Intersection ID: 42559	Main Street: ENEIDA_SUE_DR	Cross Street: LUNDY_LN	Location:	S
ADA ID: C576C0493ED4	Ramp Type: Perp	Initial Pass/Fail: Fail	Overall Compliance: No	Severity Score: 22.5

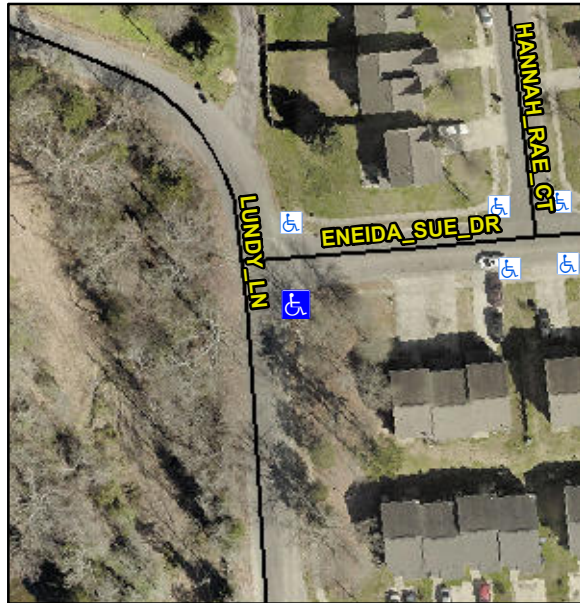
**Not Found, R304.5.1, R304.2.2,
R304.5.3**

Compliance	Description	Data	Compliance	Description	Data
N/A	Ramp Length (in)	48.5	No	Ramp Slope (%)	8.4
No	Ramp Width (in)	44.0	No	Ramp XSlope (%)	3.9
N/A	Flare Type LT	N/A	N/A	Flare Type RT	N/A
N/A	Flare Slope LT (%)	N/A	N/A	Flare Slope RT (%)	N/A
N/A	Flare Traversable LT?	N/A	N/A	Flare Traversable RT?	N/A
N/A	Landing Length (in)	N/A	N/A	DWS Provided?	N/A
N/A	Landing Width (in)	N/A	N/A	DWS Contrast?	N/A
N/A	Landing Slope (%)	N/A	N/A	DWS Length (in)	N/A
N/A	Landing X Slope (%)	N/A	N/A	DWS Full Width?	N/A
N/A	Landing Curb? (Y/N)	N/A	N/A	DWS Offset (in)	N/A
N/A	Shared Landing?	N/A			
N/A	Gutter Ponding?	N/A	N/A	Gutter Slope (%)	N/A
N/A	Gutter Lip Ht (in)	N/A	N/A	Gutter X Slope (%)	N/A
N/A	Painted X Walk1?	No	N/A	Painted X Walk2?	N/A
	X Walk 1 Direction	To N		X Walk 2 Direction	N/A
N/A	X Walk 1 Width (in)	N/A	N/A	X Walk 2 Width (in)	N/A
	X Walk 1 Slope (%)	4.5		X Walk 2 Slope (%)	N/A
	X Walk 1 X Slope (%)	2.4		X Walk 2 X Slope (%)	N/A

Remove & Replace Entire Ramp.
